PRMU20240406

**EAST TOWN CROSSING  
BUILDING 'F'  
PIONEER & SHAW PUYALLUP WA**

| REVISIONS   |                        |
|-------------|------------------------|
| TITLE:      | SITE PLAN REF ONLY     |

**AS1.0**

**3 OVERALL SITE PLAN - PHASE 1 & 2**  
SCALE: 1" = 40'

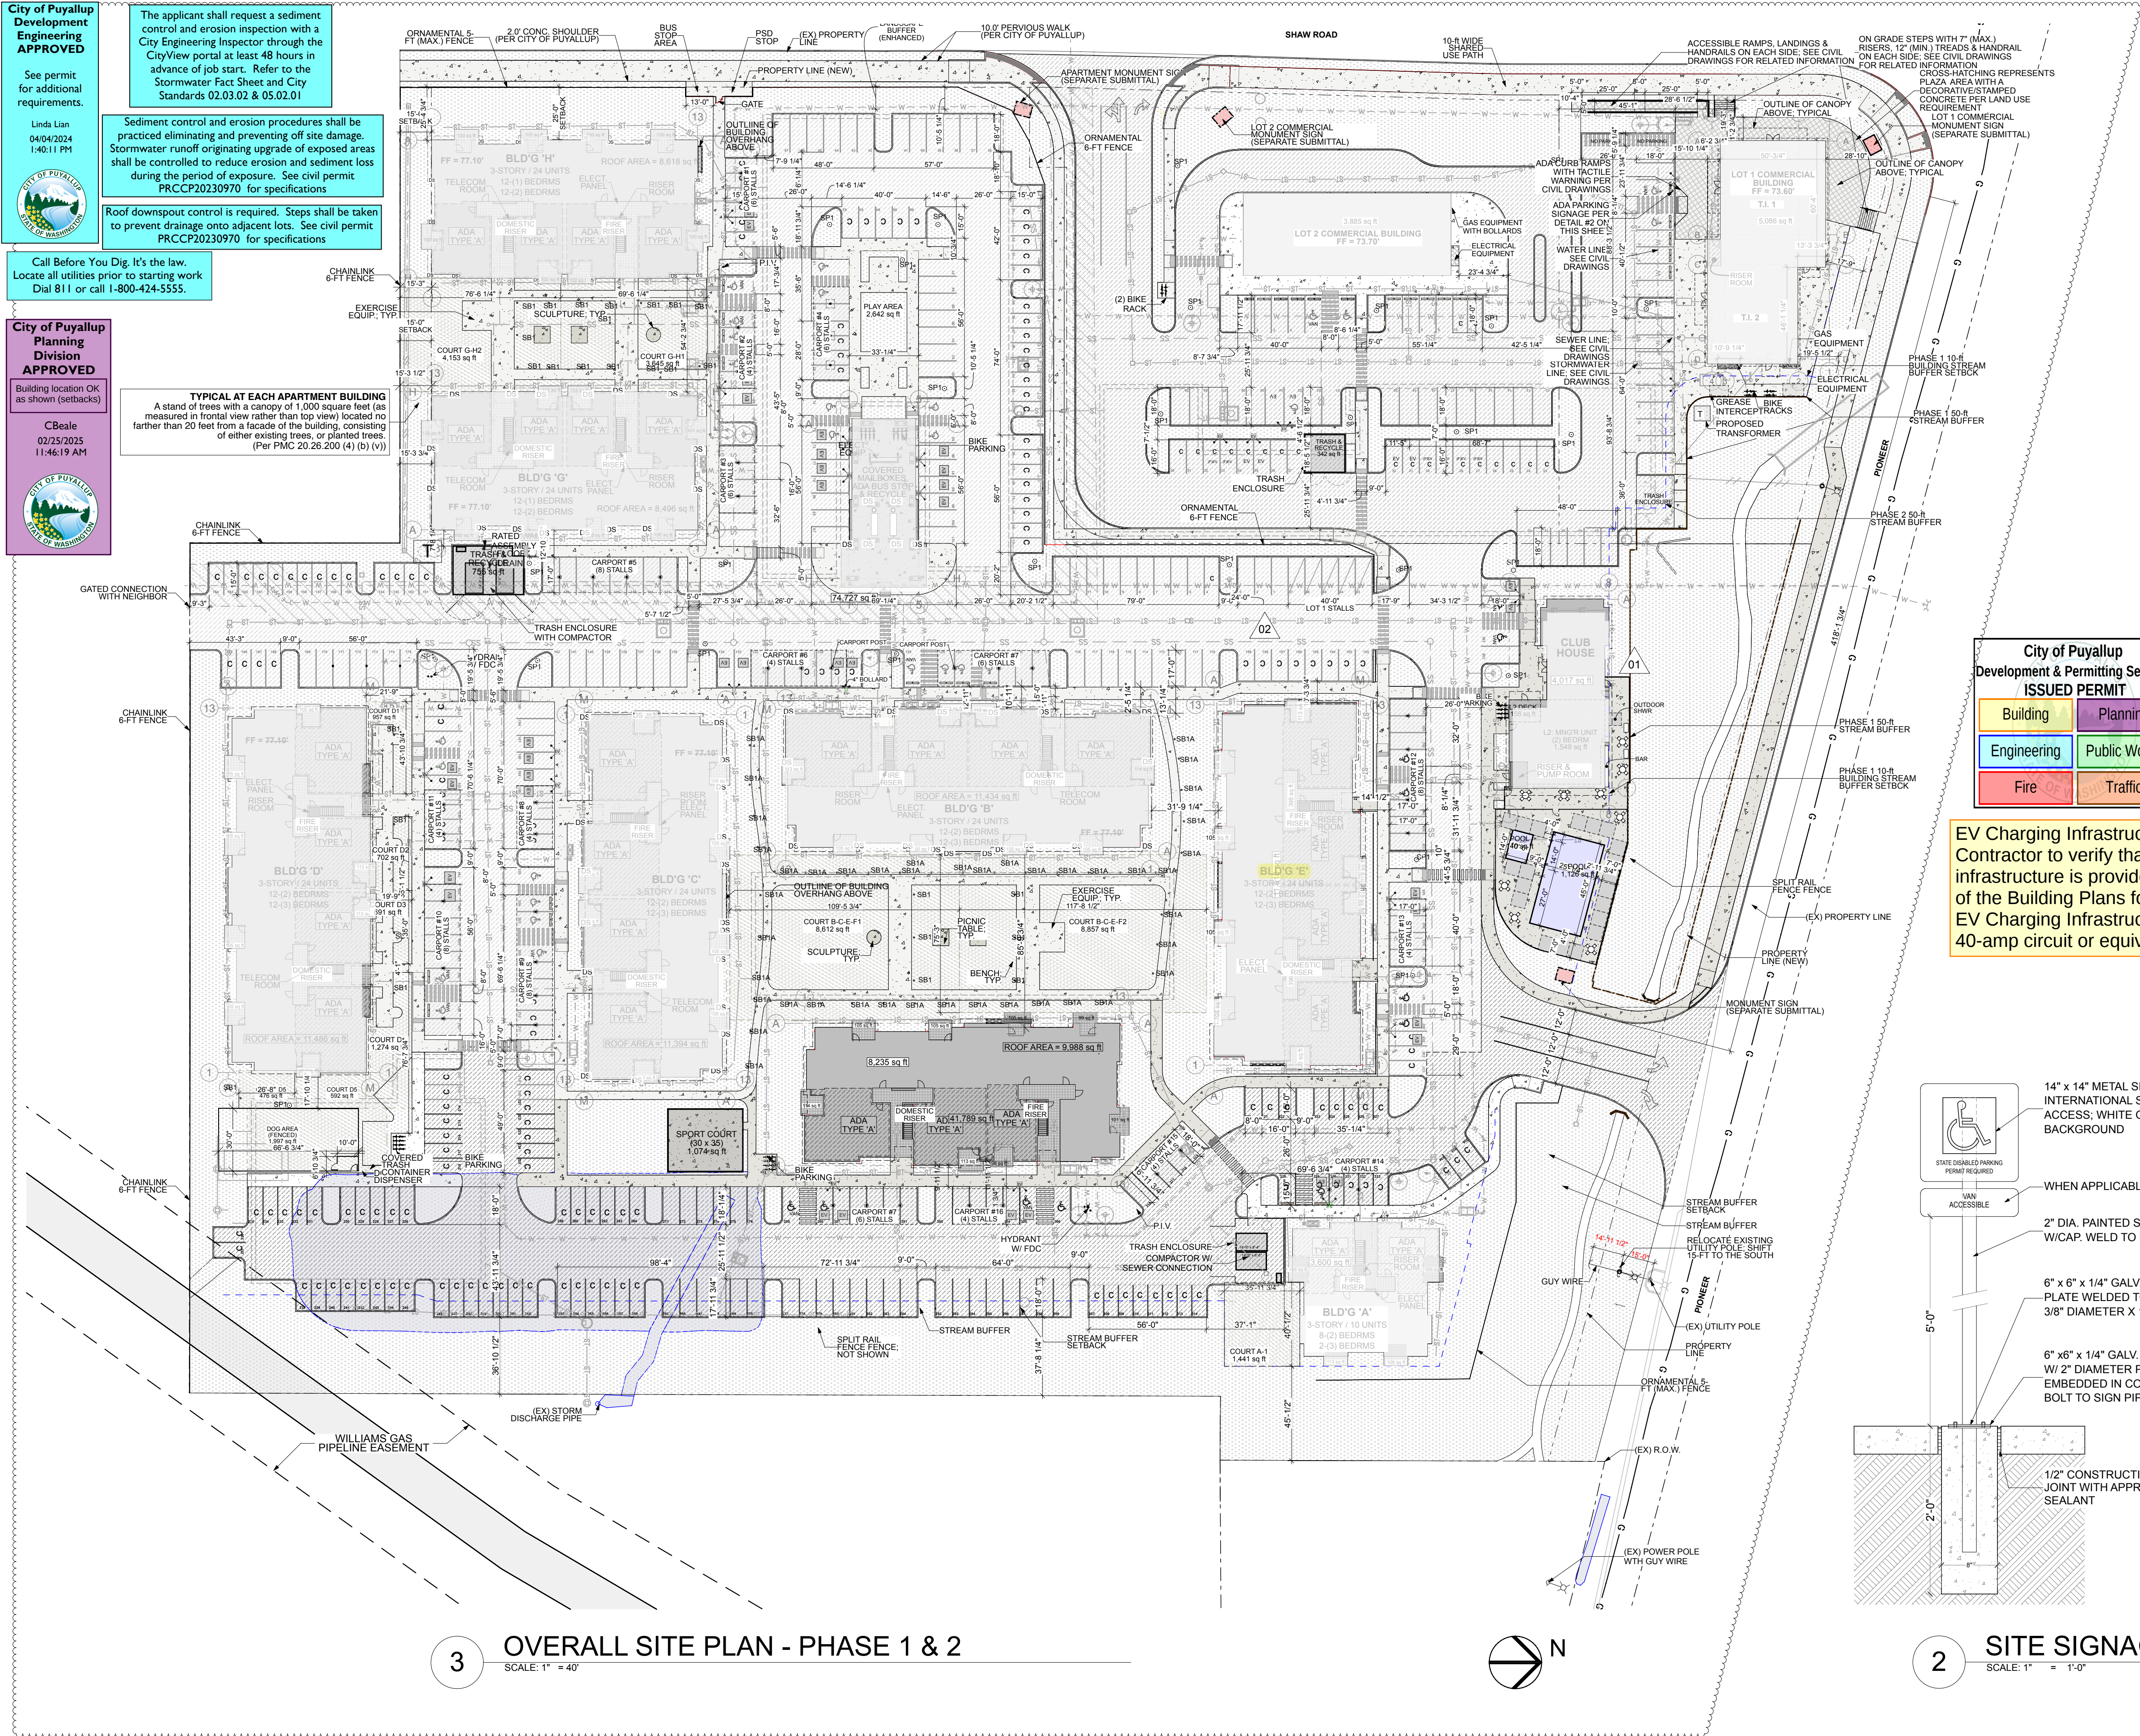
The applicant shall request a sediment control and erosion inspection with a City Engineering Inspector through the CityView portal at least 48 hours in advance of job start. Refer to the Stormwater Fact Sheet and City Standards 02.03.02 & 05.02.01

Sediment control and erosion procedures shall be practiced eliminating and preventing off site damage. Stormwater runoff originating upgrade of exposed areas shall be controlled to reduce erosion and sediment loss during the period of exposure. See civil permit PRCCP20230970 for specifications

Roof downspout control is required. Steps shall be taken to prevent drainage onto adjacent lots. See civil permit PRCCP20230970 for specifications

Building location OK as shown (setbacks)

A stand of trees with a canopy of 1,000 square feet (as measured in frontal view rather than top view) located no farther than 20 feet from a facade of the building, consisting of either existing trees, or planted trees.  
(Per FMC 20.26.200 (4) (b) (v))

**2 SITE SIGNAGE**  
SCALE: 1" = 1'-0"

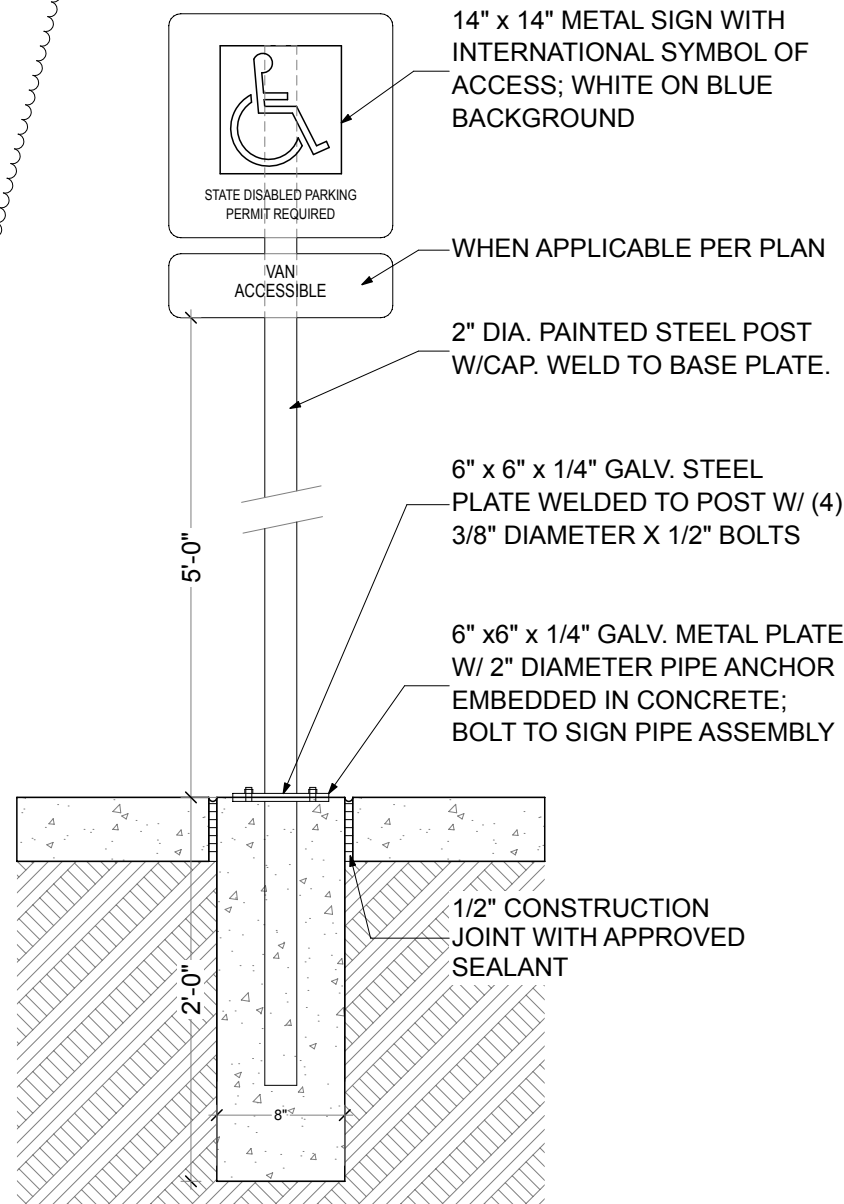
**EV Charging Infrastructure:**  
Contractor to verify that the required number of EV infrastructure is provided prior to Final. See sheet AG1.2 of the Building Plans for the minimum amount needed.  
EV Charging Infrastructure includes either a 208/240v 40-amp circuit or equivalent EV charging station.
